WestConnex M4-M5 Link

*State Significant
Infrastructure
Modification
Assessment
(SSI-7485 MOD 4)*

July 2020

Figure 1 | Location of Glebe Island construction ancillary facility (outlined in red)
(Source: Glebe Island Construction Ancillary Facility Modification Report, TfNSW, 2020)

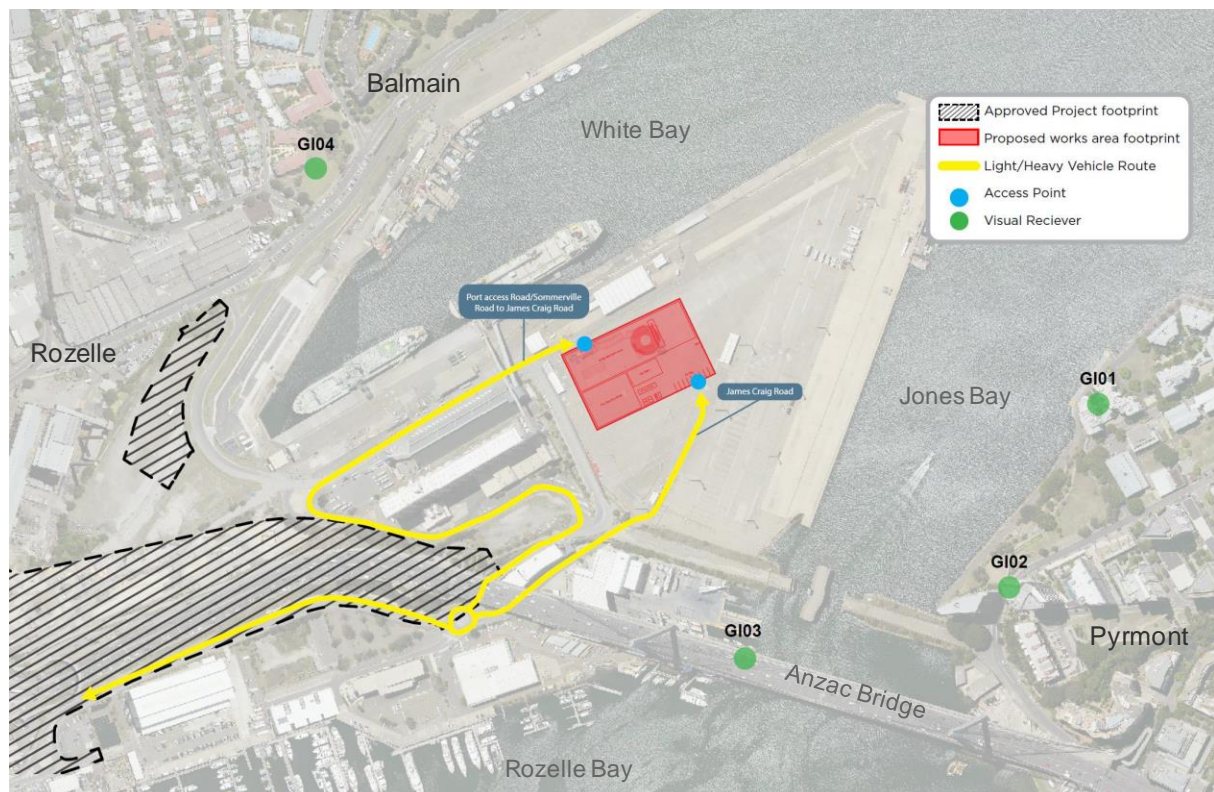
The proposed ancillary facility includes fencing, a demountable office, portable ablutions and lighting and will be used as an assembly area for large equipment such as bridge girders and drainage pipework. These facilities may introduce visual amenity changes from locations surrounding the site. The key receivers are located approximately 350-500 metres away and labelled as GI01, GI02, GI03 and GI04 in **Figure 1**.

Visual impacts on the receivers at GI04 would be limited as views to the site are restricted by Ausbarge Wharf at White Bay and existing structures to the north and west of the site (**Figure 5**). Although the facility would be visible from GI01, GI02 and GI03, the views would be mitigated by distance. In addition, the facility would be located in the middle of an existing hardstand area which is surrounded by industrial activities, and the built elements would be visually consistent with the existing industrial infrastructure on Glebe Island. Depending on timing, construction of the Multi-user Facility and Glebe Island Concrete Batching Plant and Aggregate Handling Facility maybe underway while the facility is in use and would provide further screening of the construction ancillary facility.
